STAFF REPORT 10/26/2022

SUBJECT: Tripoli Mixed-Use Project (Proposed Revisions)

SPECIFICS: Amendments to Conditional Use Permit (CUP) 351 and Architectural Review (AR) 22-04 for the PUD (Planned Unit Development) Overlay Zone guidelines, design revisions and modifications to conditions of approval for a mixed-use development consisting of 108 apartment units and 2 retail units on 2.8 acres of vacant C-G (General Commercial) zoned property at the northeast corner of Cesar Chavez Street and Bagdad Avenue (APN# 778-081-003 and -001) Applicant: Chelsea Investment Corporation

Figure 1: Site Plan (Original)

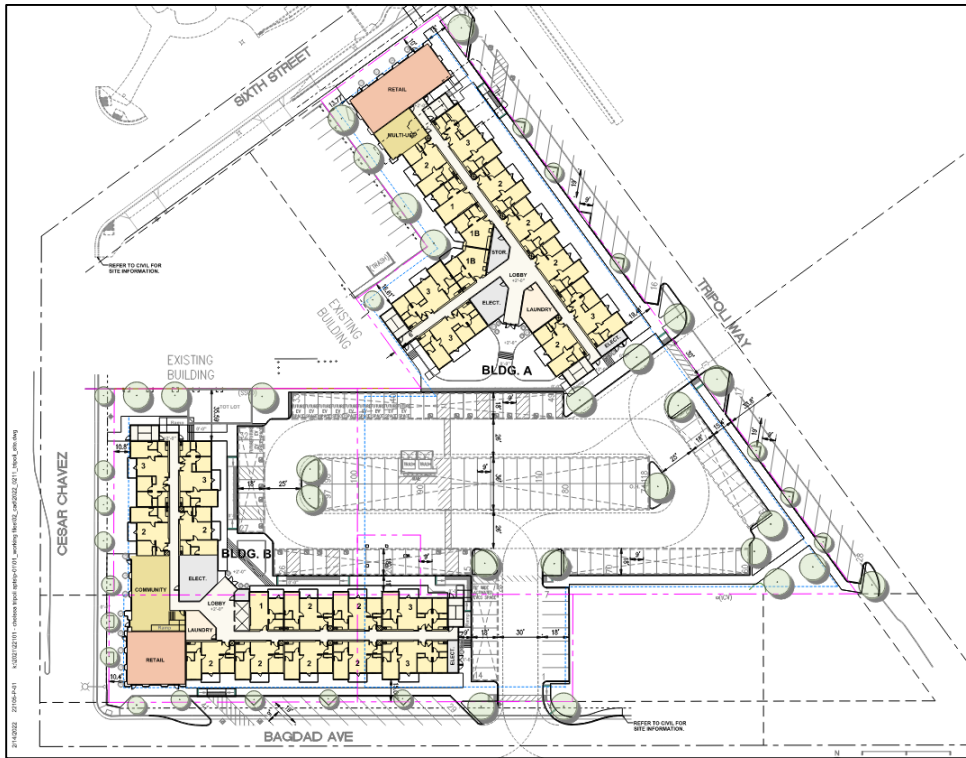
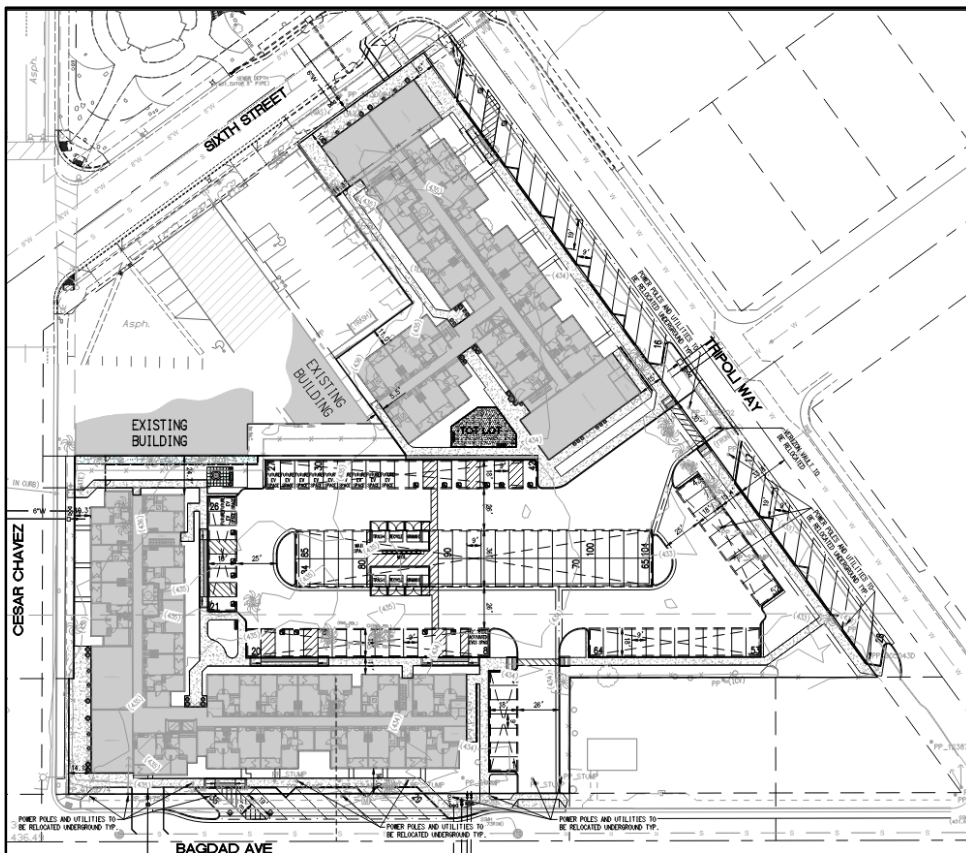
The applicant proposes modification of an approved mixed-use development consisting of 108 apartment units and 2 retail spaces within 2 buildings in the Pueblo Viejo District. Building A was approved for a 3-story; 49,794 sq. ft. building located toward the Southwest corner of 6th Street and Tripoli Avenue. Building B was approved as a 4-story, 71,079 sq. ft. building located toward the Northeast corner of Bagdad Avenue and Cesar Chavez Street. Both buildings would be constructed near property line with building frontages on 6th Street, Tripoli Way, Bagdad Avenue and Cesar Chavez Street and on-site parking oriented behind the buildings consistent with goals of the Pueblo Viejo Revitalization Plan. The orientation of the buildings support the City's goals of promoting a walkable downtown environment with a well-designed public realm.

The applicant proposes to maintain the same unit count of 108 apartments with 1-3 bedroom unit options, but proposes to reduce the size of all units and the unit number in Building B in order to reduce the size of Building B from 4-stories to 3-stories. The community lounge space is proposed to be merged into Building A and total community lounge space reduced by 158 sq. ft. The community space will include kitchen space, restrooms, and 6 computer stations. The retail space

available for the project would increase by 1,548 sq. ft. under the new proposal with two retail suites in each building.
